End-user Software Release Notes

Infinity® Acute Care System

Software VG7.1

End-user Software Release Notes for Infinity® Acute Care System (IACS) VG7.1

Figure 1: QR Code in System Setup Menu and Service Menu

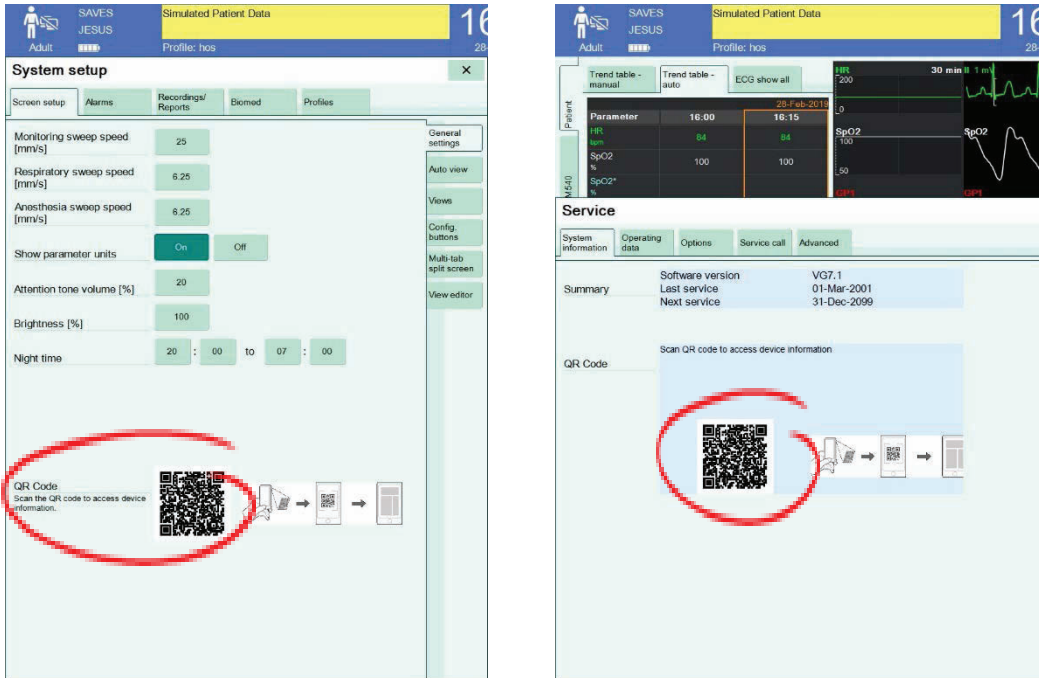
QR code: IACS now offers a QR code illustrated in Figure 1. This allows the user to access device's information directly by scanning it. It is available in the System setup menu and the Service menu.

Figure 2: Hybrid Alarm tone setup

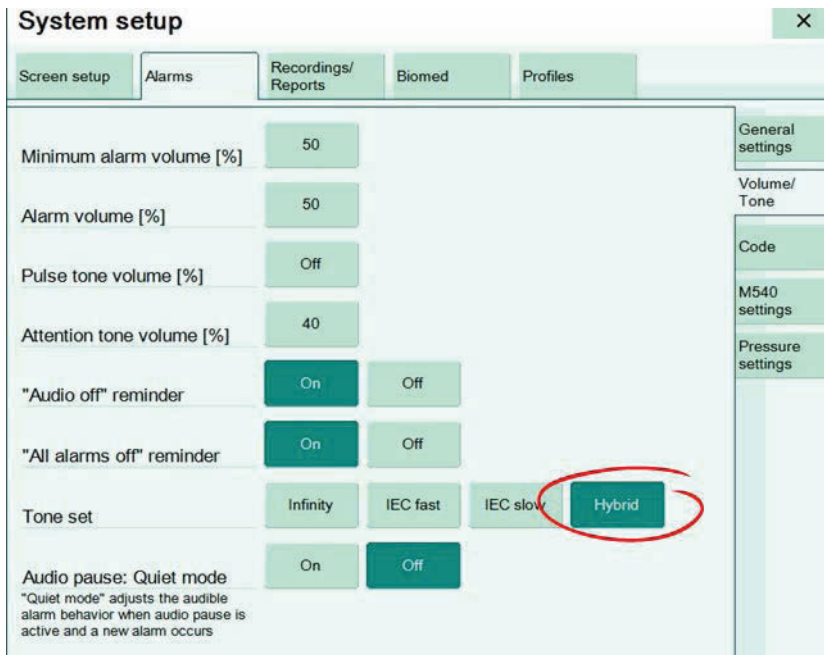
Hybrid alarm tone set: IACS now offers the ability to have a fourth alarm tone set, called hybrid, which is a combination of IEC low-grade and medium-grade tones and Draeger Infinity high-grade tone. This user feedback has been implemented to make high grade alarms more alerting while reducing alarm fatigue by using softer tones for medium and low grade alarms. The setting is available in the current Alarms menu in System setup behind password protection, illustrated in Figure 2.

Figure 4: Impedance respiration menu

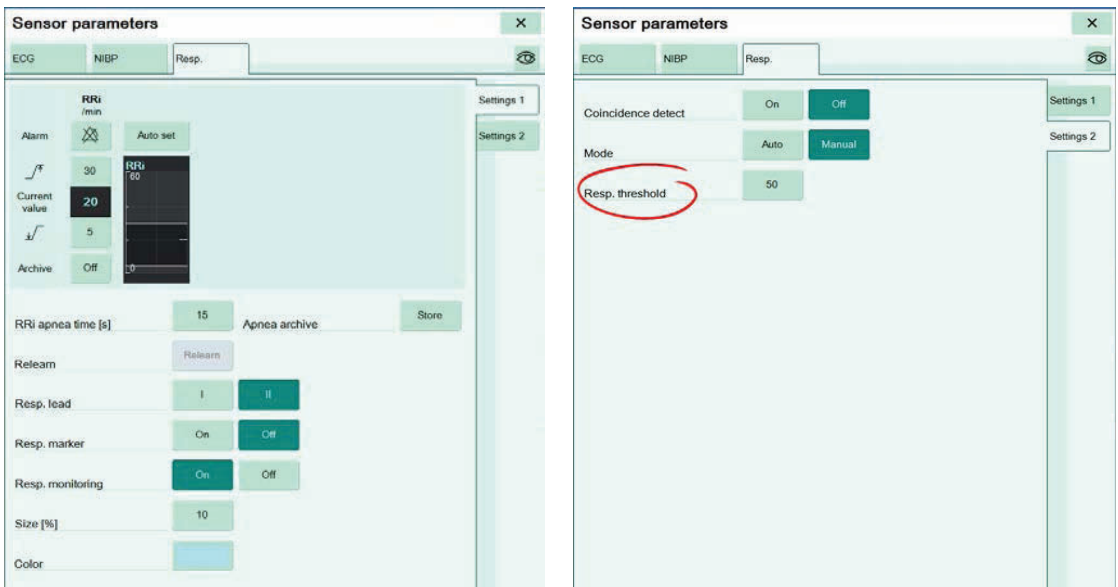
Impedance respiration: IACS now offers the ability to configure, in manual mode, the respiration threshold independently from the waveform size. The enhancement includes the display of a bracket on the waveform channel illustrated in Figure 3. This allows users to clearly set the threshold according to the amplitude of the waveform and thus avoid false apnea alarms, illustrated in Figure 4. The Respiration menu has been slightly modified to accommodate for this change. In parallel, enhancements in the filtering of the respiration signal has allowed to reduce the number of false positive apnea alarms.

Figure 5: Available configurations

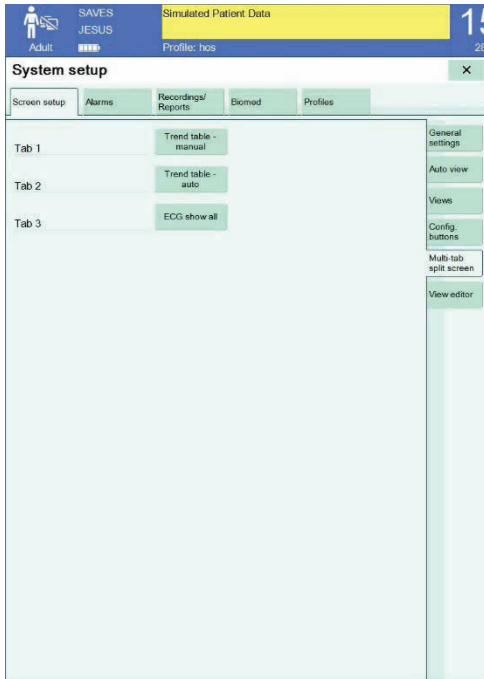
Split screen – tabular trend auto update: IACS now offers the ability to have the tabular trend in the split screen to update automatically. The user can therefore now choose between automatic or manual trend tables in the split screen, illustrated in Figure 5 and 6.

Figure 7: External device Reconnect button setup and access

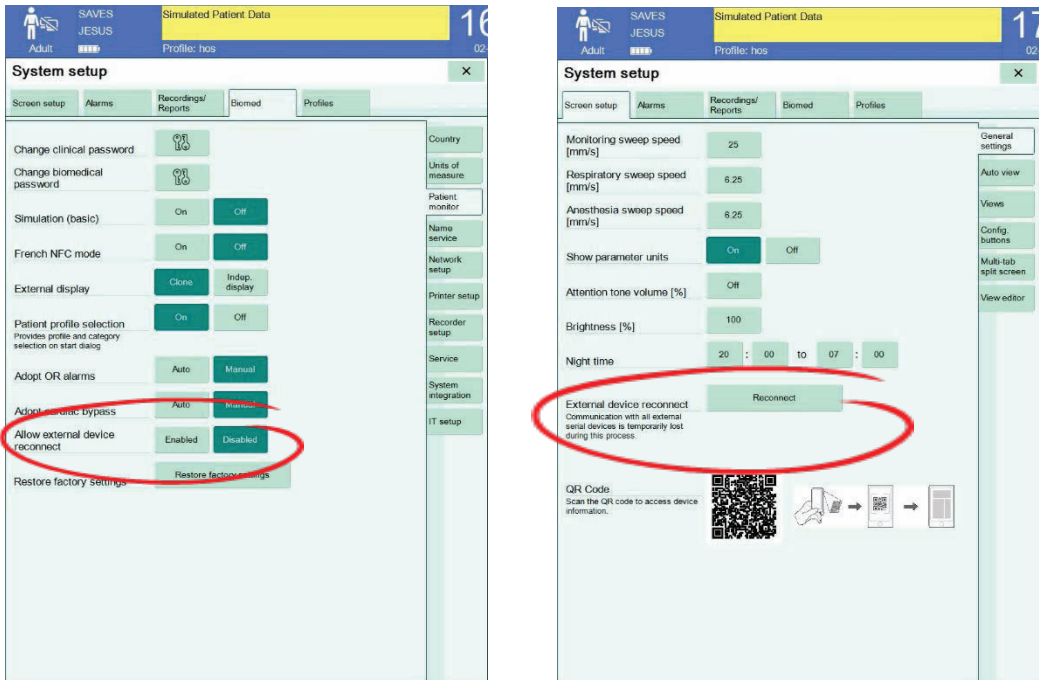
External device Reconnect button: IACS now offers the ability to reconnect third party devices when one or several are digitally disconnected. The user therefore does not have to physically disconnect and reconnect the devices and/or powercycle the cockpit to get the devices connected again. This functionality needs to be enabled in the Biomed menu and is accessible in the Screen setup menu, illustrated in Figure 7.
